ANN ARBOR HISTORIC DISTRICT COMMISSION

Staff Report

ADDRESS: 1435 Broadway Street, Application Number HDC17-247

REPORT DATE: December 14, 2017

FRONT ELEVATION scale $\frac{1}{8}''=1'-0''$

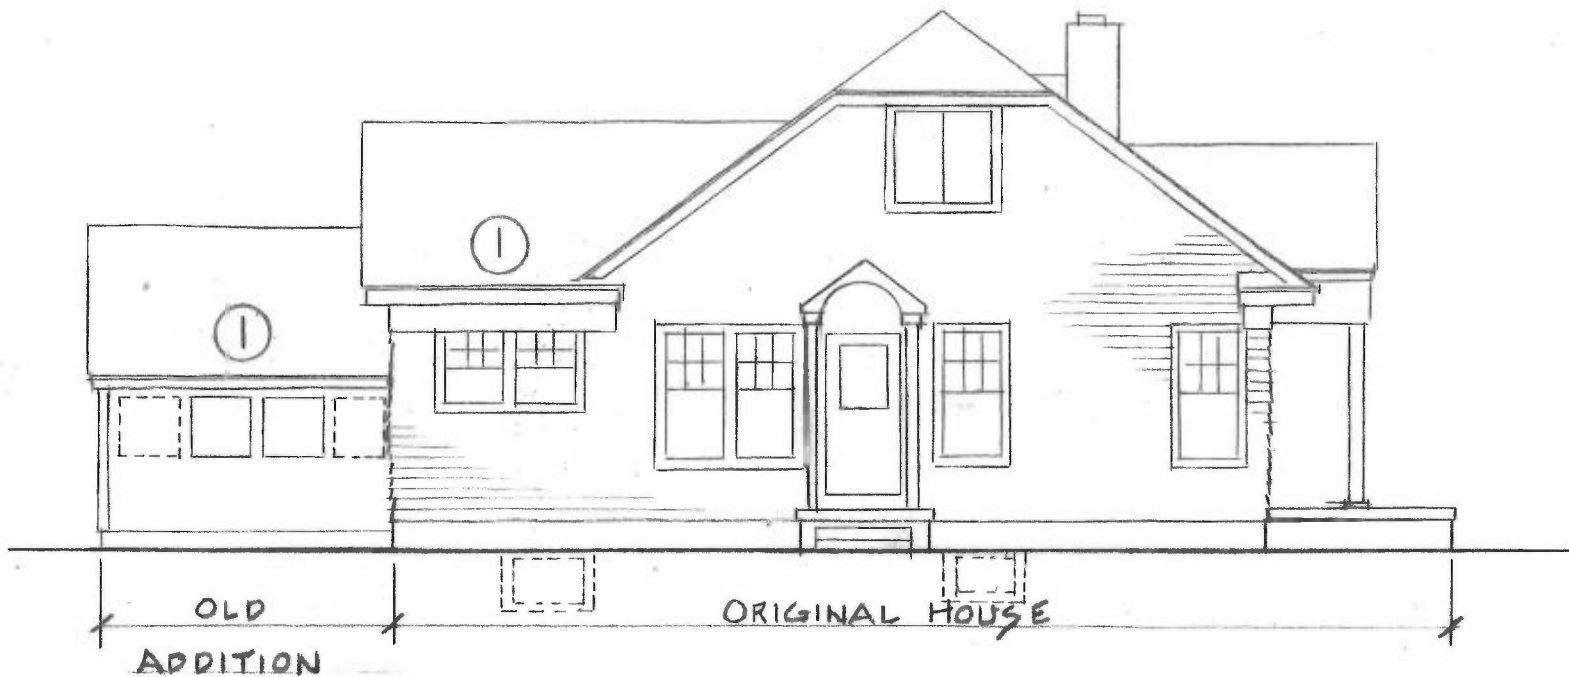
2. *Front porch and gutters:* The front porch is the original concrete slab, and in poor condition. It will need to be removed and re-poured. The original gutters may have been boxed into the eave, out of sight, but appear to have been removed. Installing gutters is necessary, and half-round gutters are appropriate for this time period.

- ① The front concrete porch is failing both in its foundation and concrete slab. This work will involve removing the porch columns and supporting the existing porch roof from the front wall. Then remove the concrete porch including the foundation. Replace with a new 42" trench footing, two courses of concrete block, and a new 4" concrete slab. Refinish the columns including new bases and re-install under porch roof.

- ② Install new gutters on eaves over the front porch, with downspouts at each end of the porch. Gutters and downspouts to be old style galvanized half-round gutters with round downspouts.

- ③ The structure at the right side of this elevation is an addition that provides protection and enclosure for a basement entrance. That structure is built in the required side setback and makes this a non-conforming property. The structure is to be removed completely and a drain is to be added to the stair-well.

LEFT SIDE ELEVATION scale $\frac{1}{8}''=1'-0''$

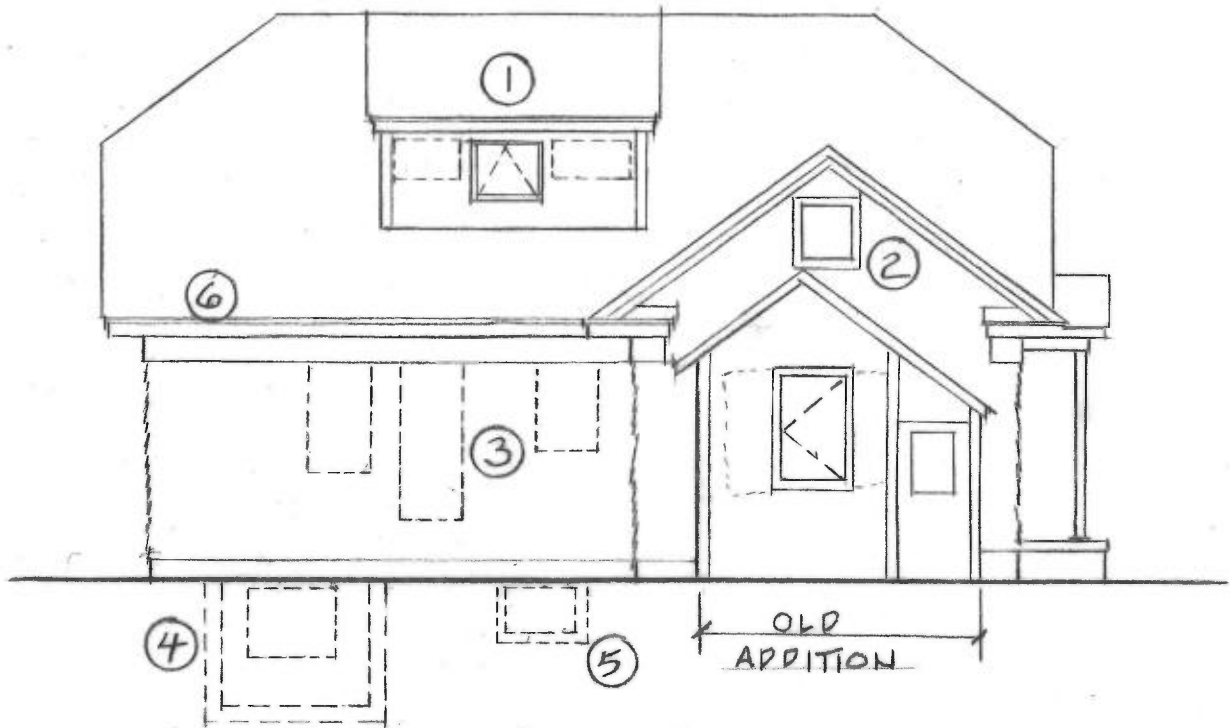
4. *Sunroom addition:* This does not appear on 1947 aerial photos. It currently has only storm windows or nothing in the openings. Most of the windows would be infilled, three would have new wood windows installed in existing openings, and a new steel door with a single light would be installed facing the backyard. The entire addition is proposed to be resided with new wood clapboard siding to match the main house. Since the sunroom does not imitate the style or trim details of the original house, staff feels that wood lap siding will not cause confusion about whether this addition is new or old. See application photo of “the old addition” and photos #6.

The "Old Addition" portion of this elevation was previously an unheated sun-porch. This structure is to be saved and re-purposed as a laundry and mud room. The work here requires all of the windows and doors of the sun-porch to be removed. There will be two new fixed windows installed on this elevation, while the remaining wall will be insulated and new wood clapboard siding will be installed matching the siding on the original house.

- ① New gutters and downspouts will be added on the eave over the kitchen windows and on the eave of the "Old Addition".

REAR ELEVATION scale $\frac{1}{8}''=1'-0''$

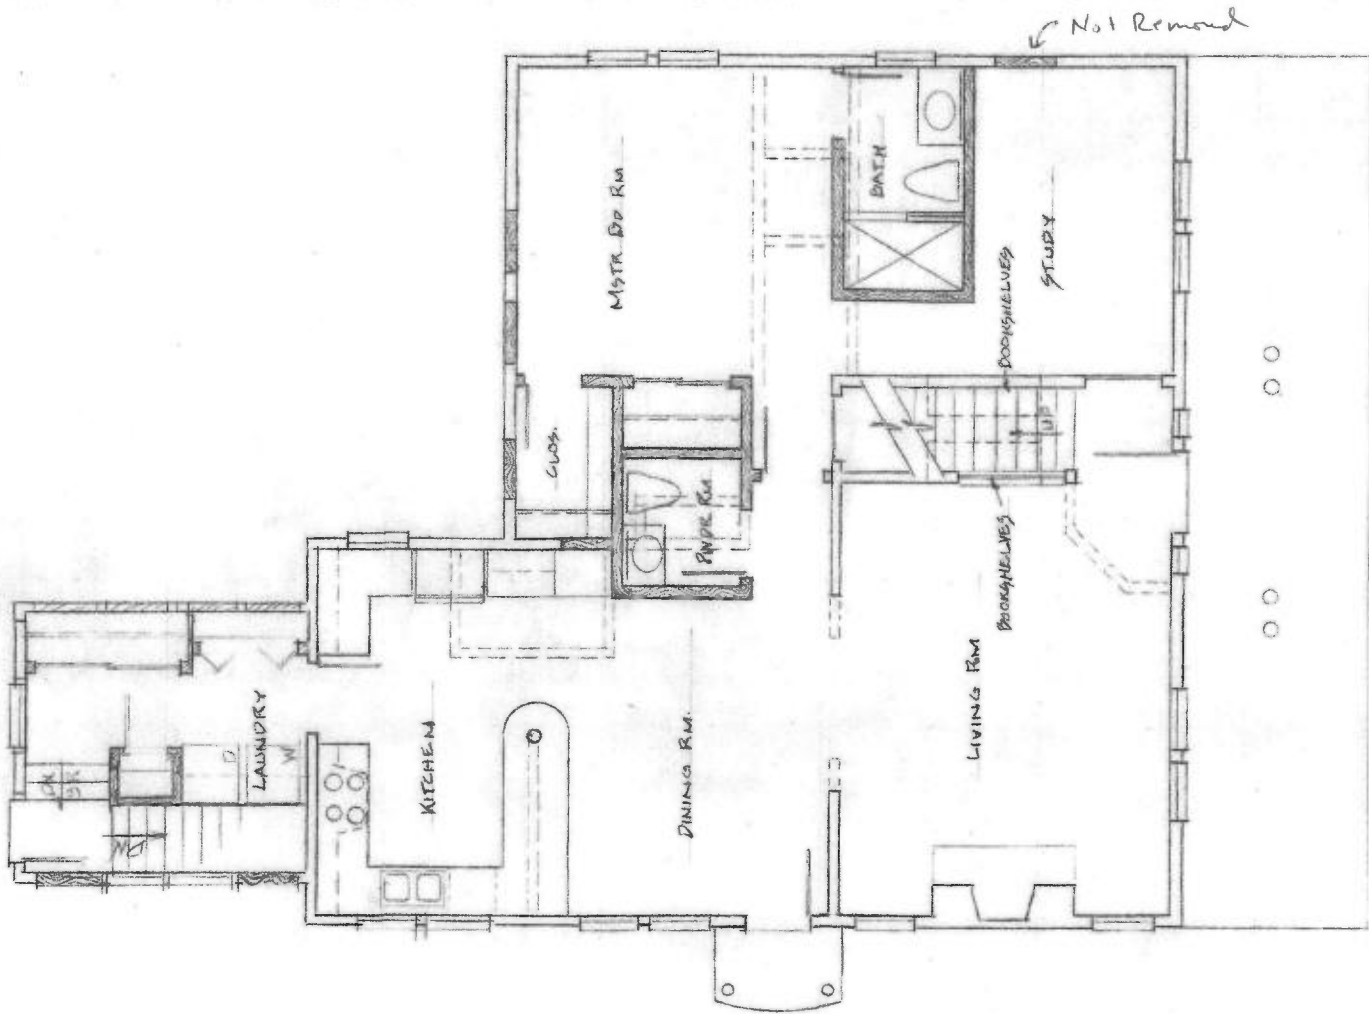
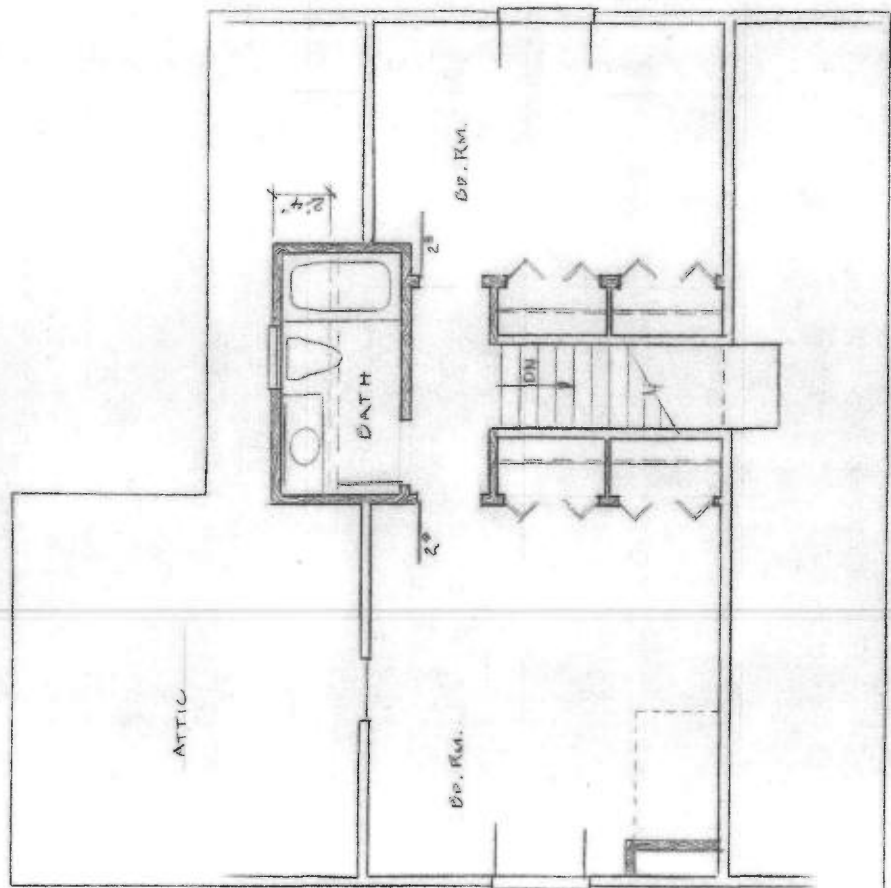
5. *Move basement window:* The basement window (marked #1 on the attachments) on the rear of the house is an 8-light double casement. This window is proposed to be removed, rehabilitated and installed on the first floor of the north/right side of the house, in a new bathroom. Moving windows is not addressed in the SOI guidelines or the Ann Arbor Historic District Guidelines. Generally, cutting in new windows on character-defining elevations is discouraged. The Commission may want to consider that the window is original to the house, and the style is distinct but compatible, and the north side of the house is visible but not prominent. The basement window opening would be converted to an egress window, which requires a larger well than the one there now. If the Commission does not approve the relocation of this window, the well could be made larger and the window appears to be big enough to be used for egress as it is (though the exact measurements are unknown).

6. *Move rear window to kitchen, also rear:* The same rationale should be applied to this window (photo #2 of the attachments). It is currently on the back of the house, and the new floorplan puts it inside a closet. It is proposed to be moved nearby, where it would replace a taller window in the kitchen. While leaving it where it is would be most appropriate, since both windows are on a not-visible rear wall, staff does not object to this work.

7. The upstairs dormer facing the rear would be expanded 2’ 4” further back. (See photos #5.) This would allow enough space for a bathroom upstairs. Two bedrooms upstairs already have egressable window openings. The expanded dormer would have a single window instead of the four small four-light ones there now, which are extremely

deteriorated. Since those windows would need to be replicated, staff prefers the new single window design, which is a telltale that “something was changed here”.

8. *Rear elevation infill*: Two windows and a door are proposed to be infilled on the rear wall of the house (photo #3). One of those windows would be moved (see above), and another would be used to repair an important front elevation window that has no sashes. Since the work is on the back of the house and both windows would remain on the structure in new locations, staff is not opposed to this work. In addition, a small basement window is proposed to be infilled with glass block. The window is not significant, and staff feels the work is appropriate.

- ① The dormer for the second floor showing on the rear roof will be extended rearward by 2'-4" in order to properly fit the second floor bath. The three existing windows are severely decayed and will be removed from the existing dormer and replaced by a single new wood awning window with insulated glass.

- ② Existing gable window to remain.
- ③ The two existing windows and the door are to be removed, framed-in and resided to match. The window coming out of the existing bath is to be reused in the kitchen as shown on the Right Side Elevation. The taller window will be used for parts to repair other windows in the house as many windows are the same size.

- ④ The northerly area-well and window are to be removed to make room for a larger egressable area-well (escape well). This window is to be re-used in the bathroom as shown on the Right Side Elevation.

- ⑤ The southerly area-well is to have the window removed (it is very decayed) and replaced with glass block fit into the existing foundation wall.
- As previously described, the "Old Addition" will have all of it's windows and doors removed and framed-in. A new wood casement window and an insulated door will be installed as shown on this elevation.
